FILE P.I. # 751420-
STP00-9252-00(007)
Fulton County
GDOT District 7 - Metro Atlanta
Johnson Ferry Road - Corridor Improvements

**DEPARTMENT OF TRANSPORTATION
STATE OF GEORGIA
PROJECT CONCEPT REPORT**

Roundabout Peer Review

Subject: RESPONSE TO ROUNDABOUT PEER REVIEW COMMENTS
Project No. STP00-9252-00(007)
P.I. No. 754120, Fulton County
COSS Project No. T-0011
Johnson Ferry Road and Glennridge Drive Connector Improvements

FIGURE 4

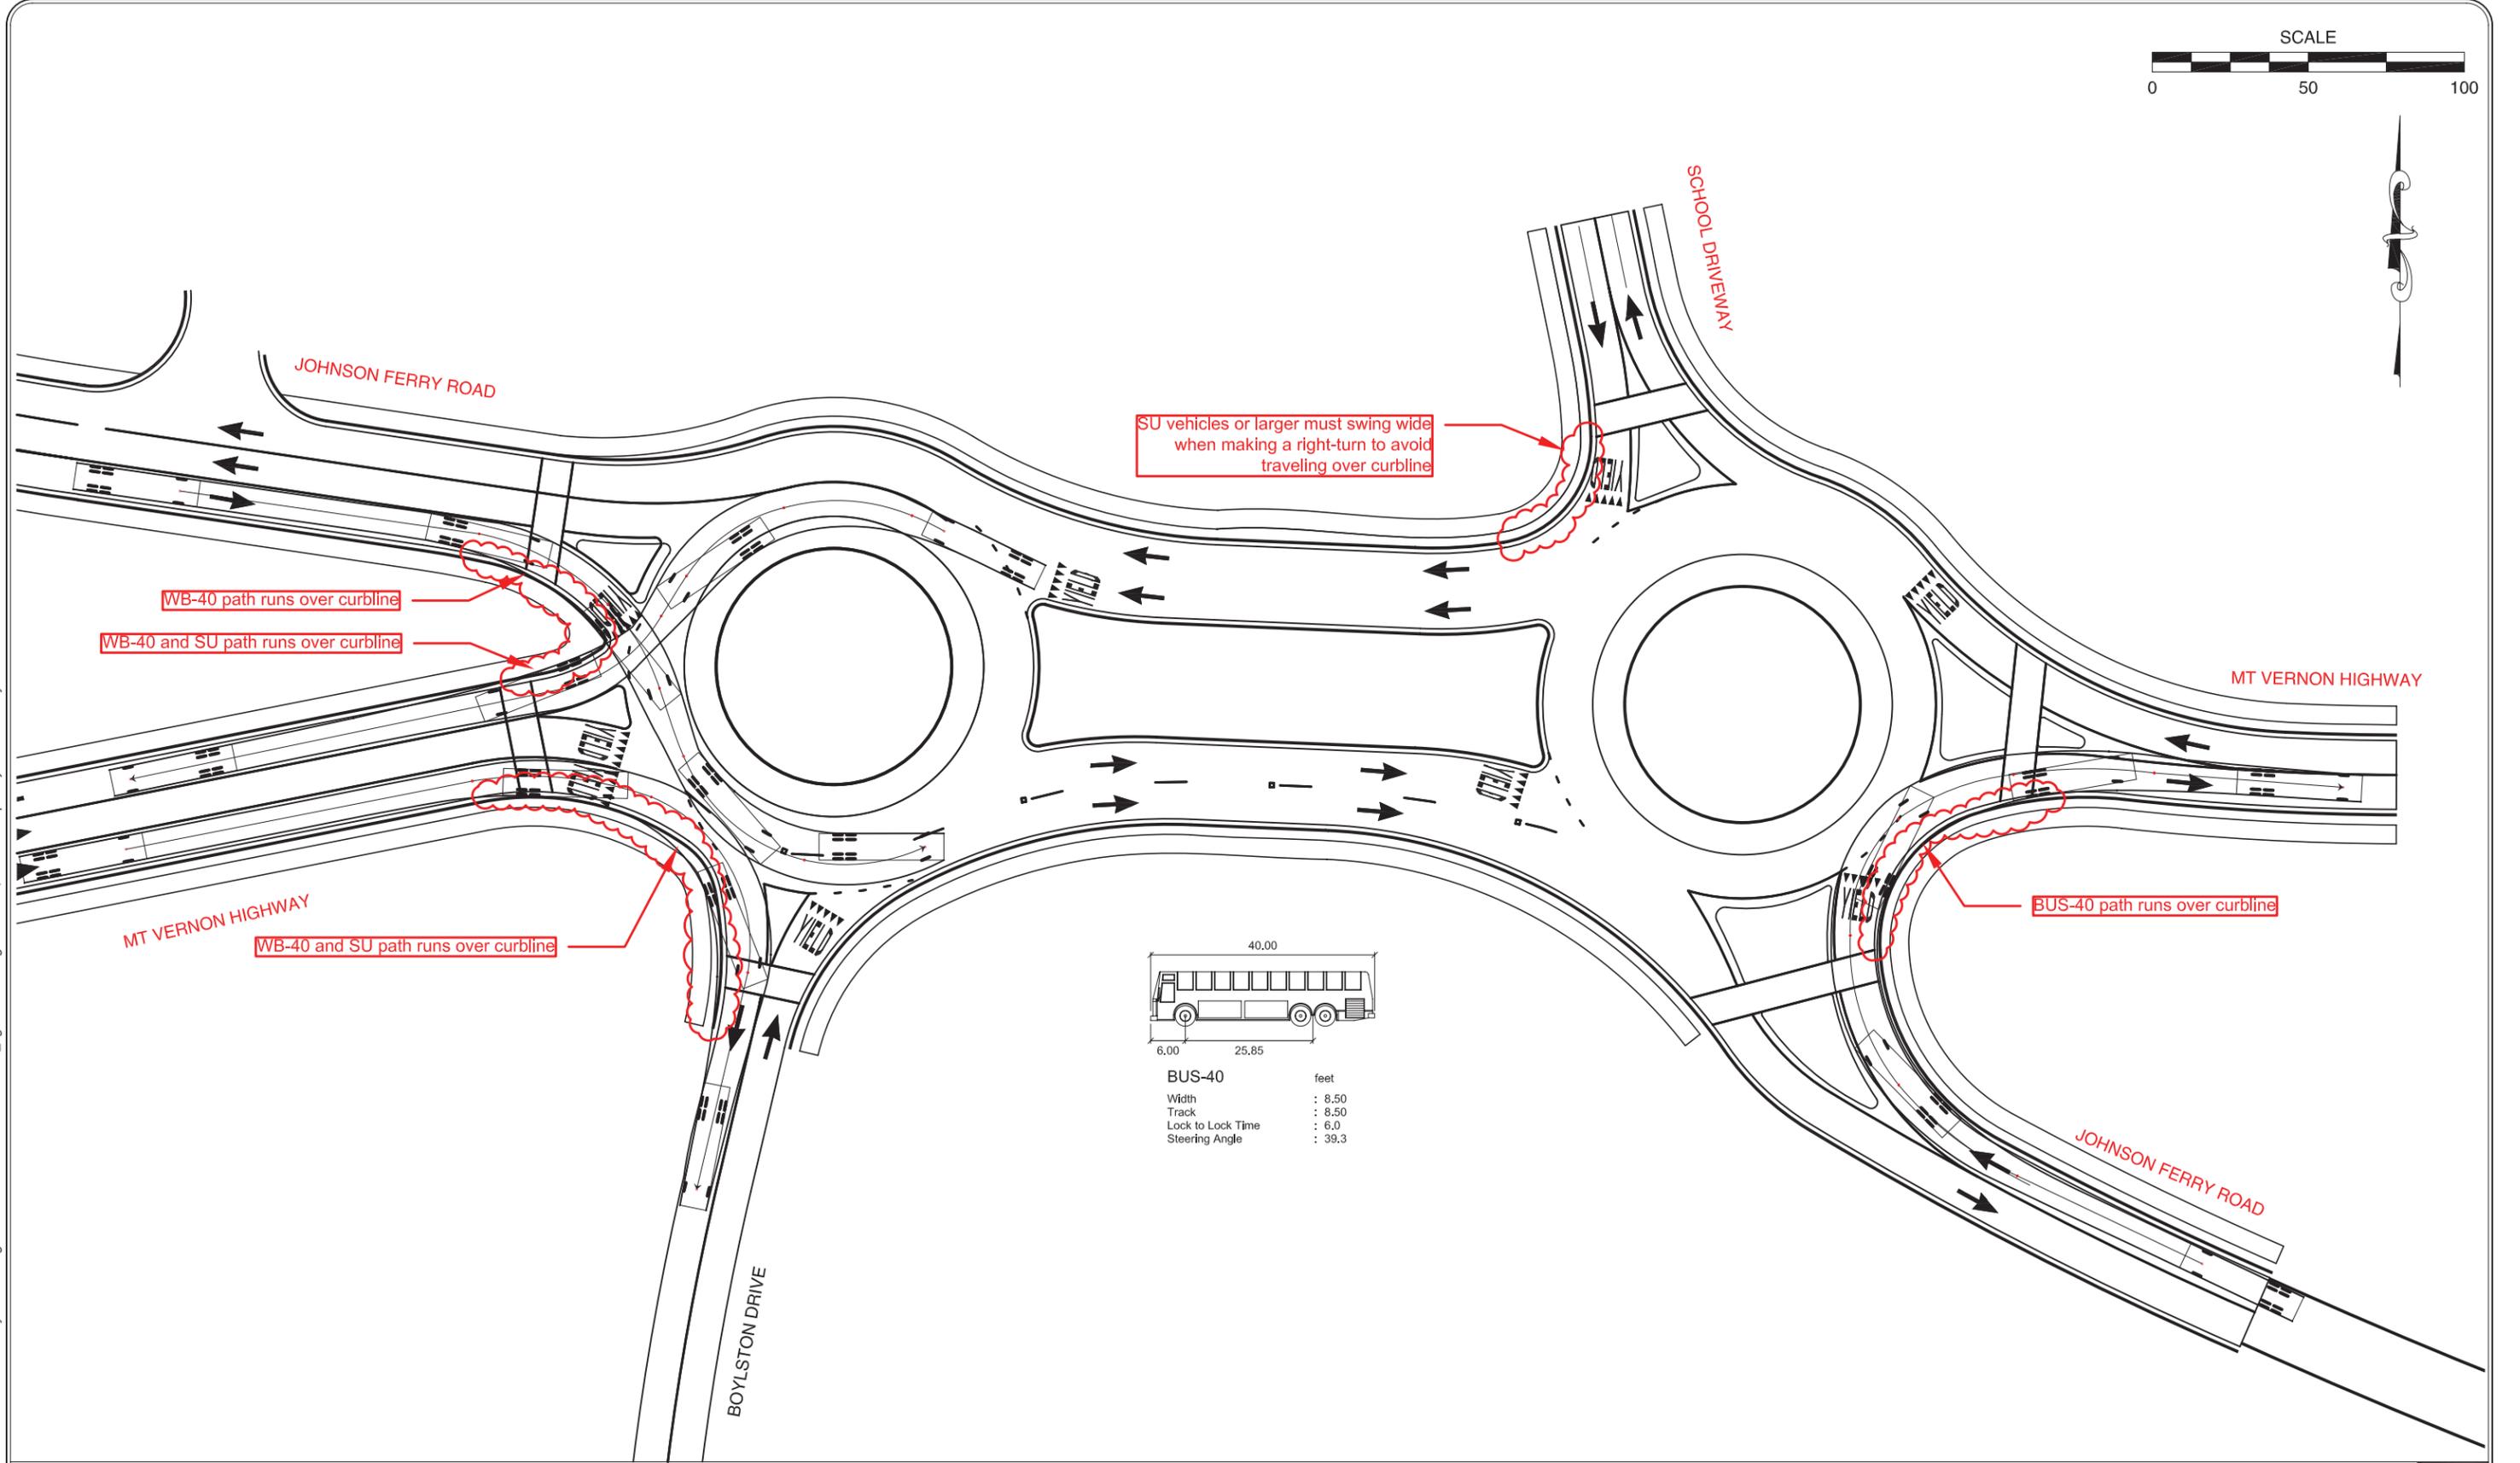
A review of the BUS-40 and SU-30 design vehicle turning templates provided by Jacobs shows that these design vehicles cannot be accommodated at multiple locations. Very limited shy distance is available at other locations. Shy distance allows for variations in vehicle paths from different drivers. NCHRP Report 672 recommends a minimum of 1 to 2 feet of shy distance between the swept path of design vehicles and each curblineline. Figure 4 summarizes the locations where BUS-40 and SU vehicles are not accommodated or shy distance is not sufficient.

BUS-40 DESIGN VEHICLE PATHS FOR SELECTED TURN MANEUVERS SANDY SPRINGS, GEORGIA

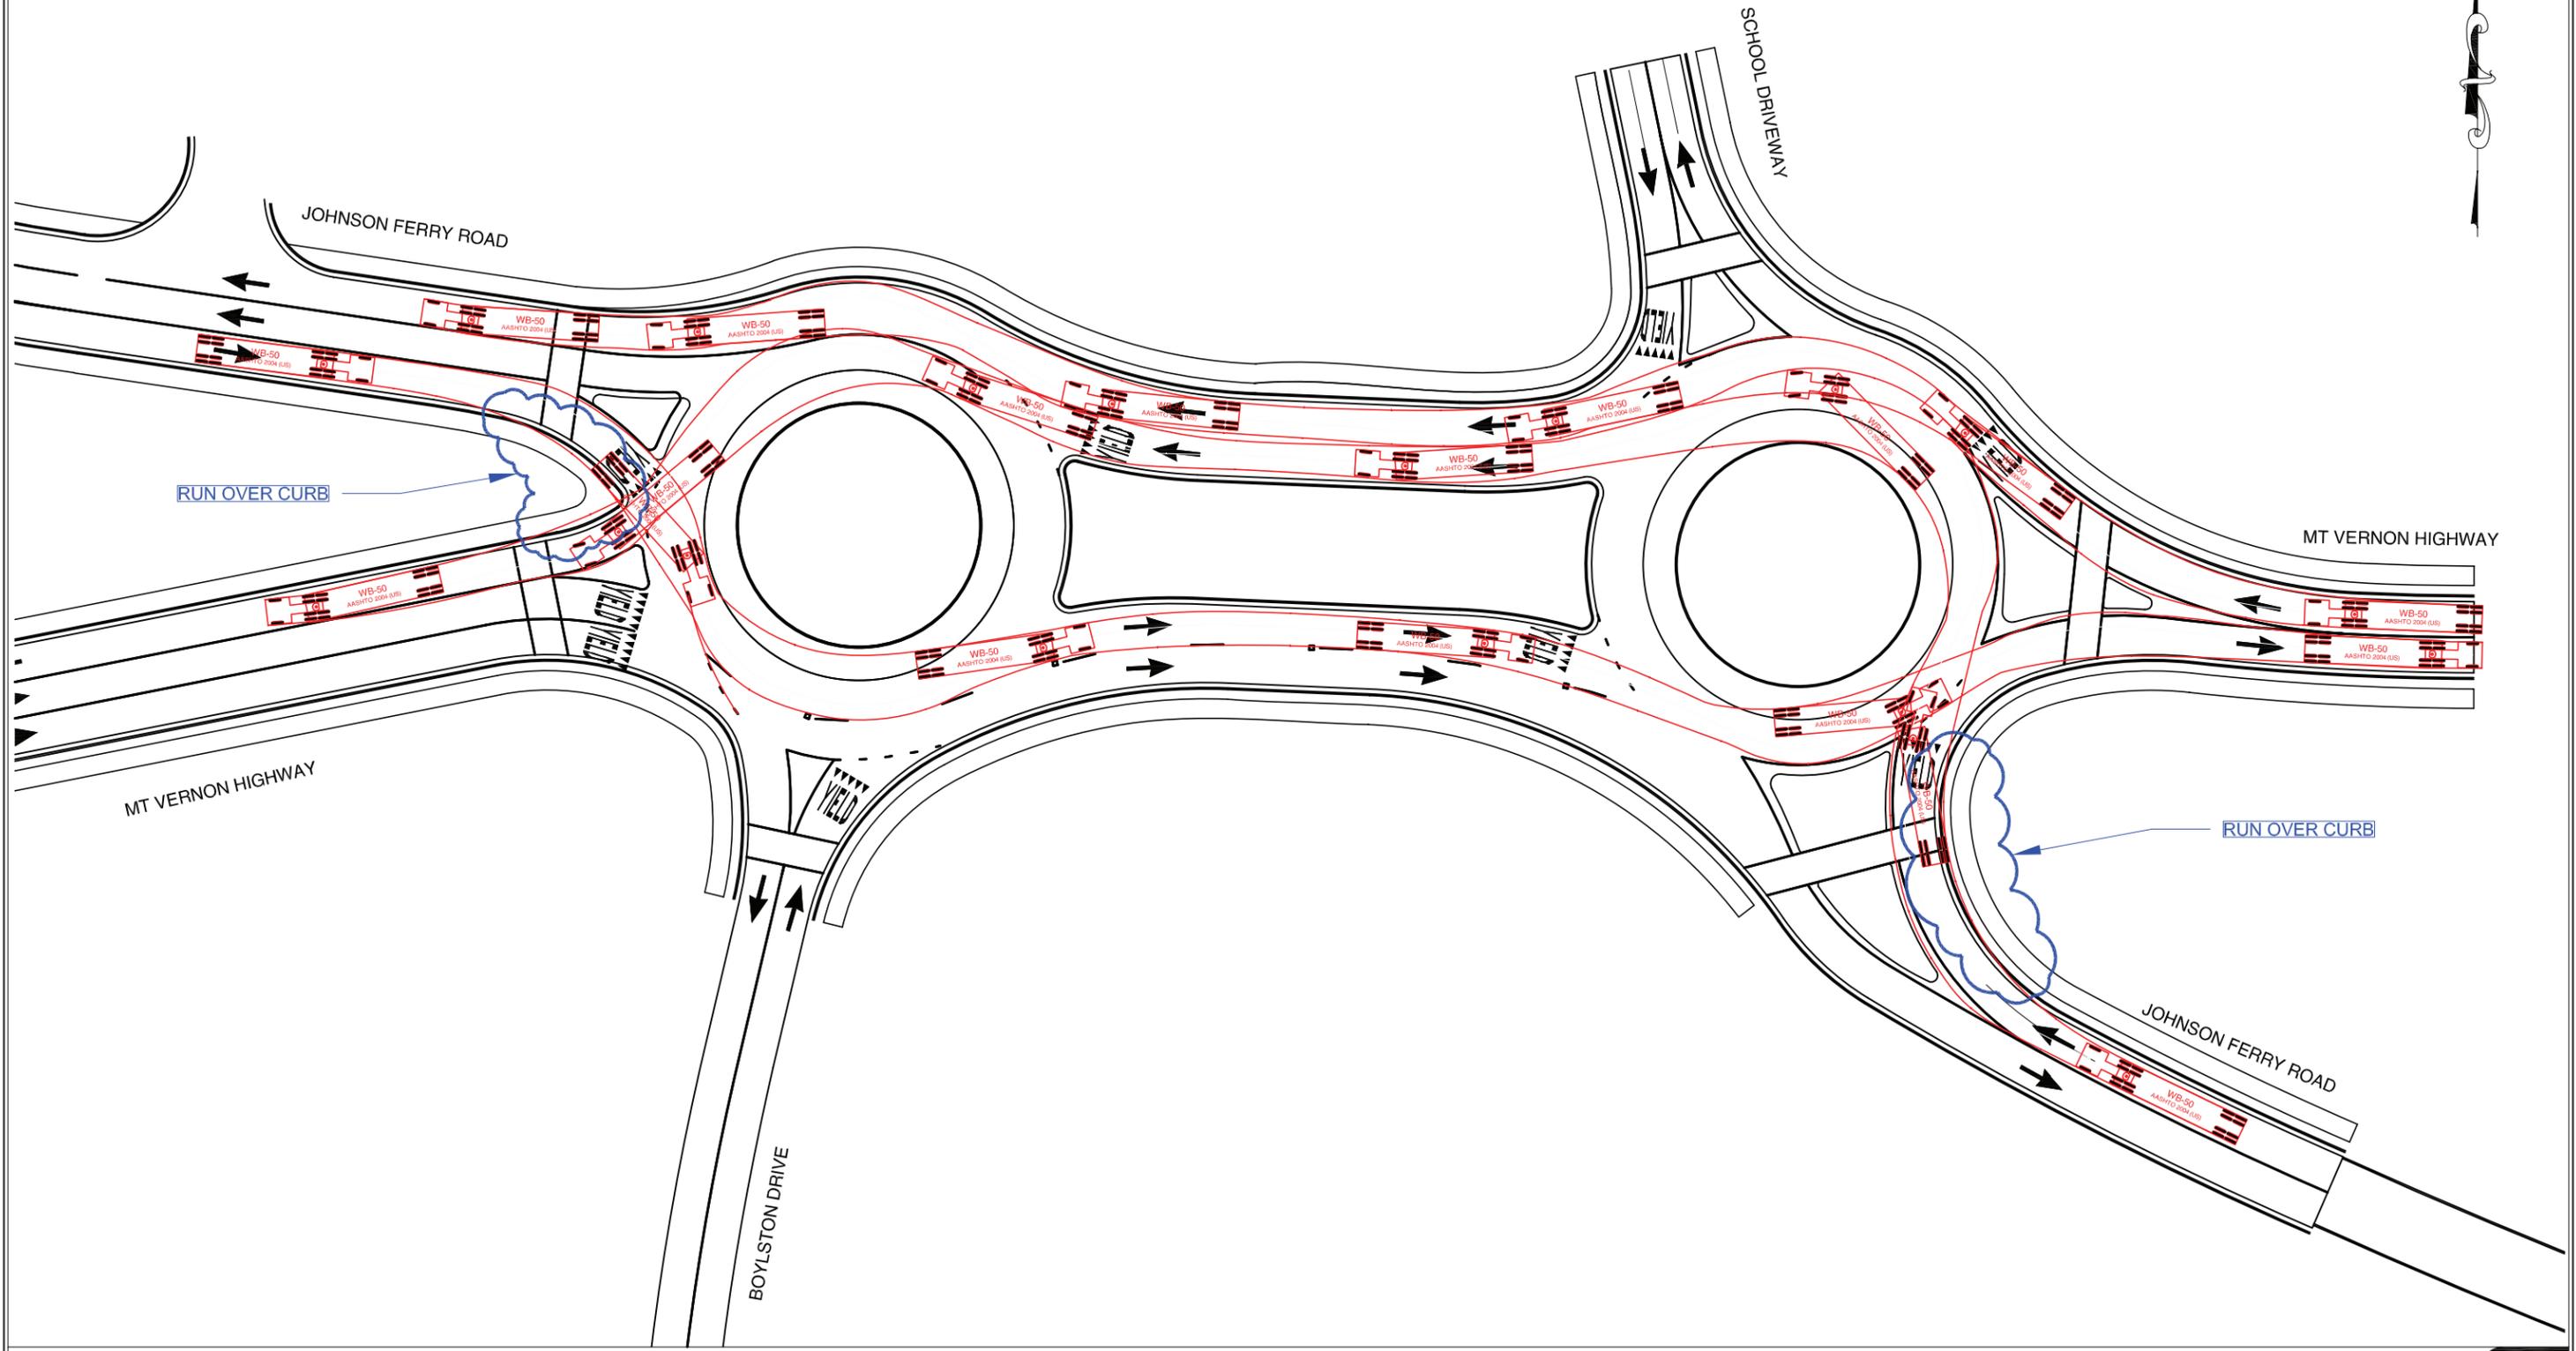
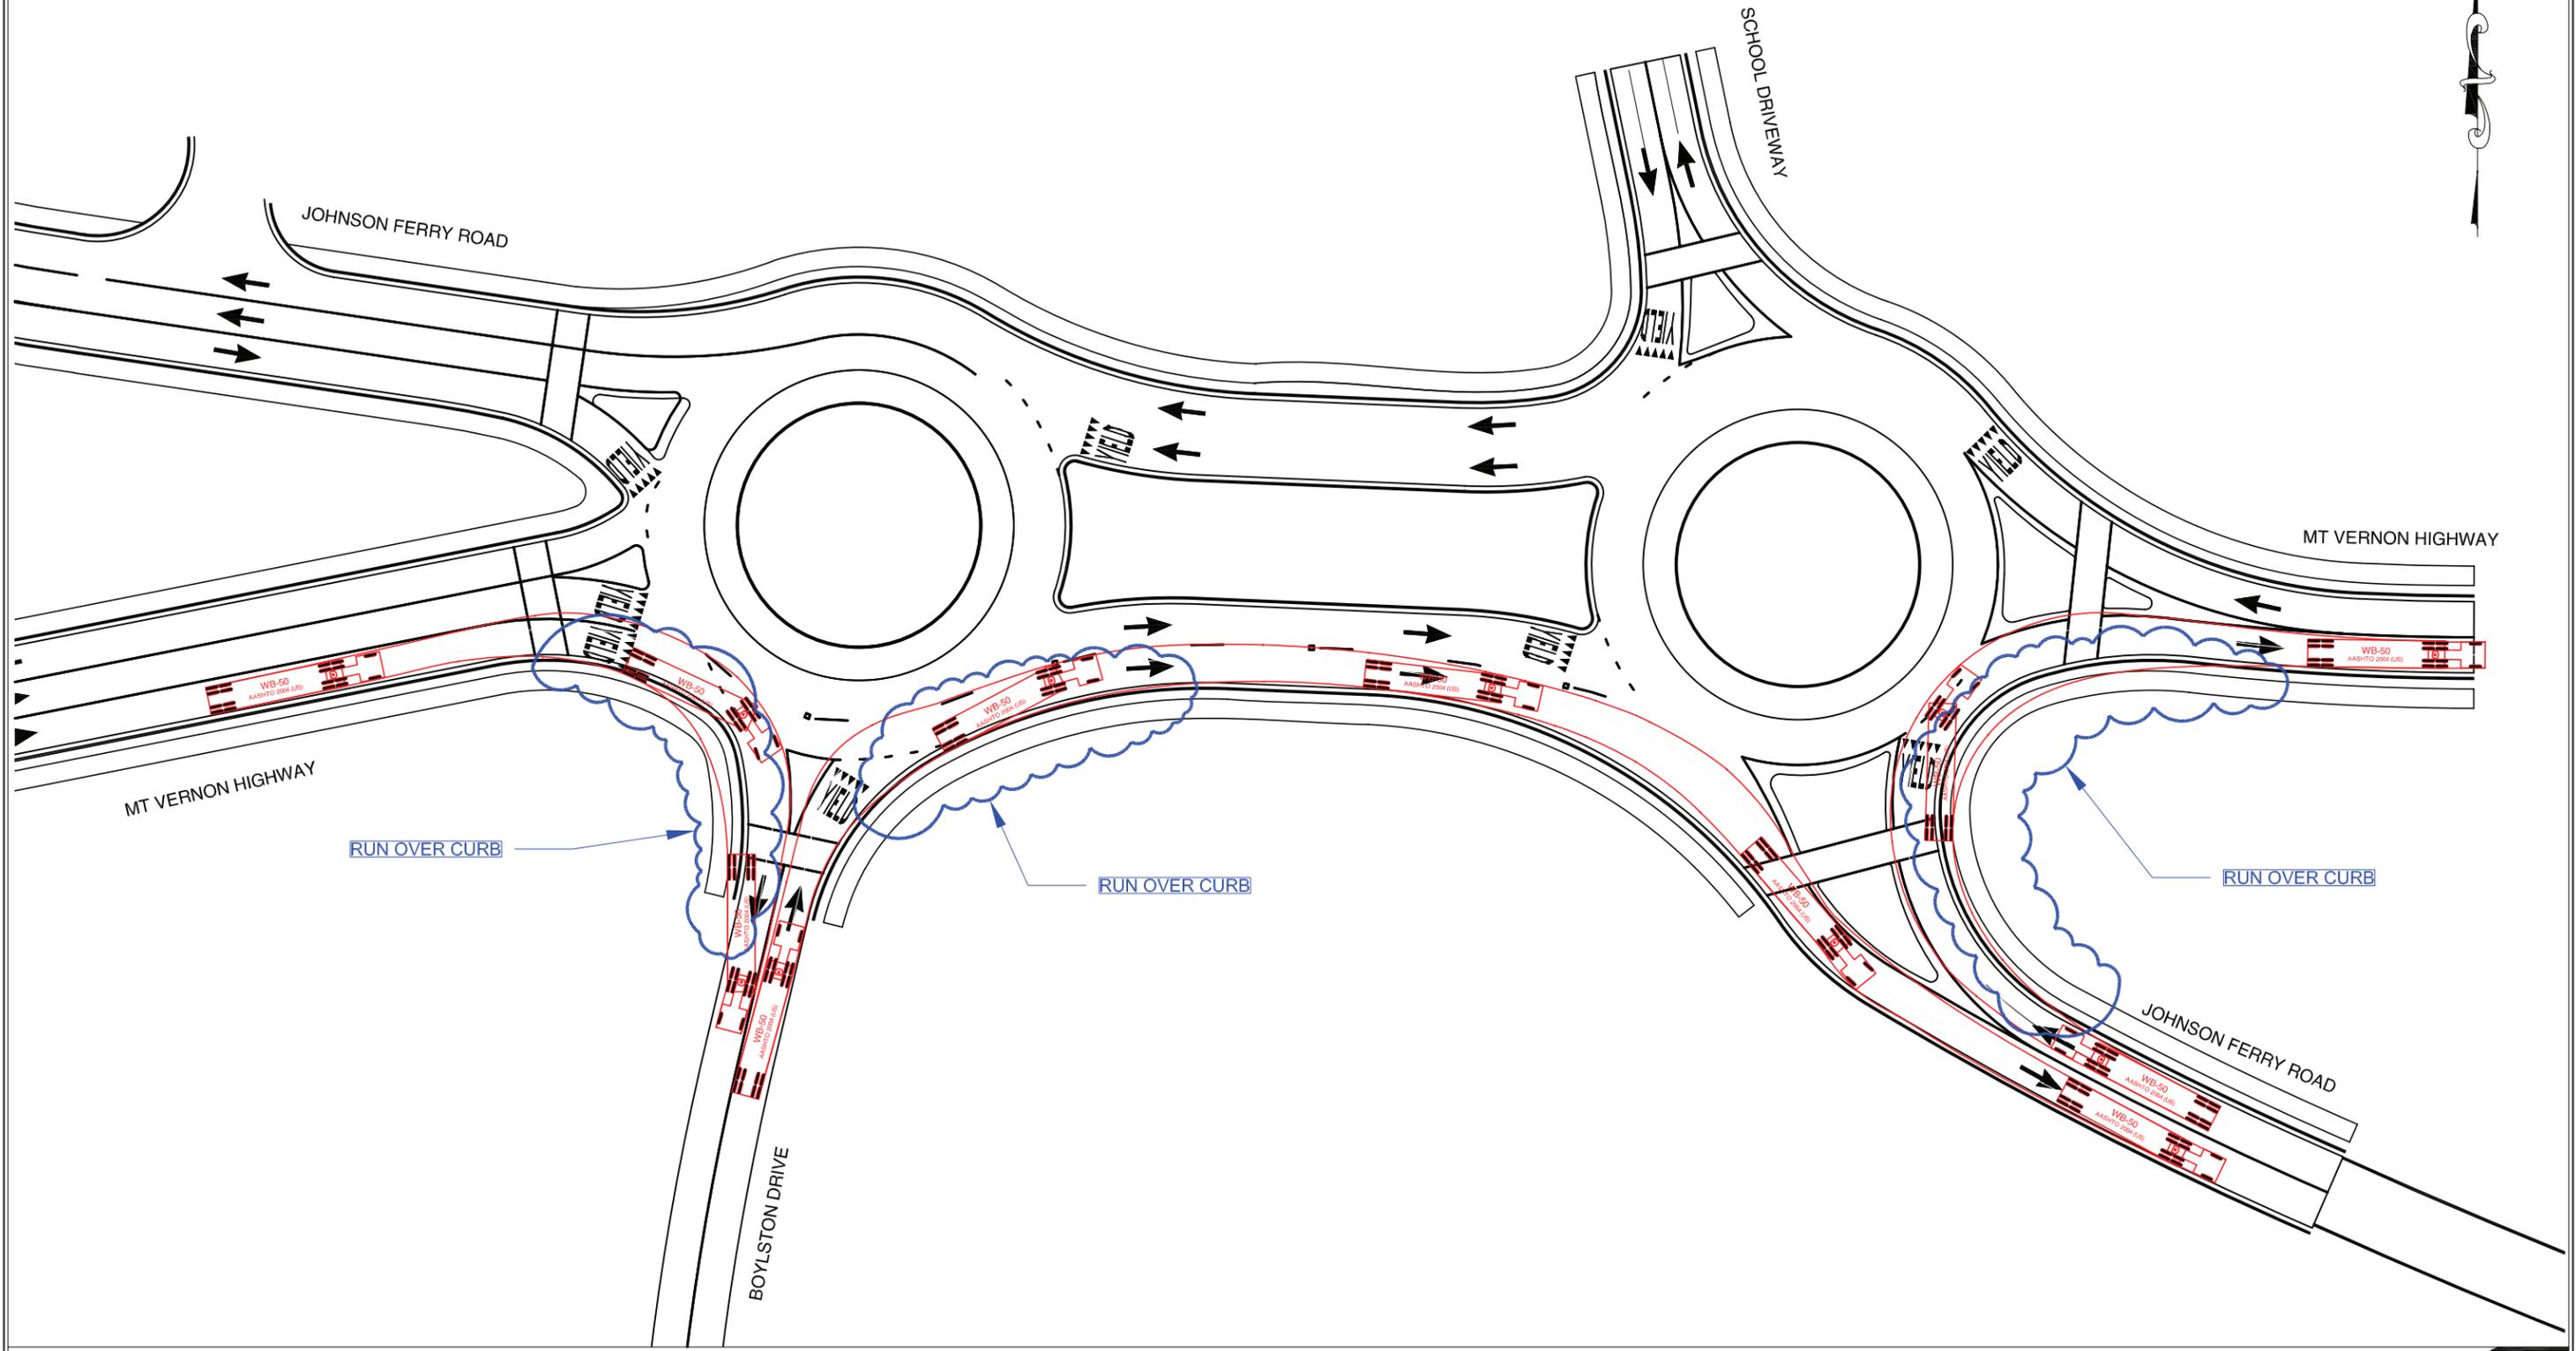
KAI also created truck turning templates using WB-50 design vehicle for certain key movements, as shown in Figures 5 and 6. This was done to evaluate where the designs may have issues with accommodating a vehicle larger than a bus. The turning templates indicate that the roundabouts are not able to accommodate WB-50 design vehicle at multiple locations. However, these locations are largely the same as those identified for the BUS-40 vehicle in Figure 4.

In general, the issues related the heavy vehicle accommodation is due to 'tight' geometry. As shown in Figure 9, the entry, exit, and circulating lane widths are consistently narrower than the typical ranges identified in NCHRP Report 672. Increasing the lane widths into the recommended ranges provided in NCHRP Report 672 is expected to address many of the identified heavy vehicle accommodation issues. However, it will also impact the fastest path speed control. Therefore, some iteration in the design will be necessary to balance the truck accommodation with vehicle speeds. Consideration should also be given to provide sufficient space for a passenger car to travel adjacent to the design vehicle through the roundabout.
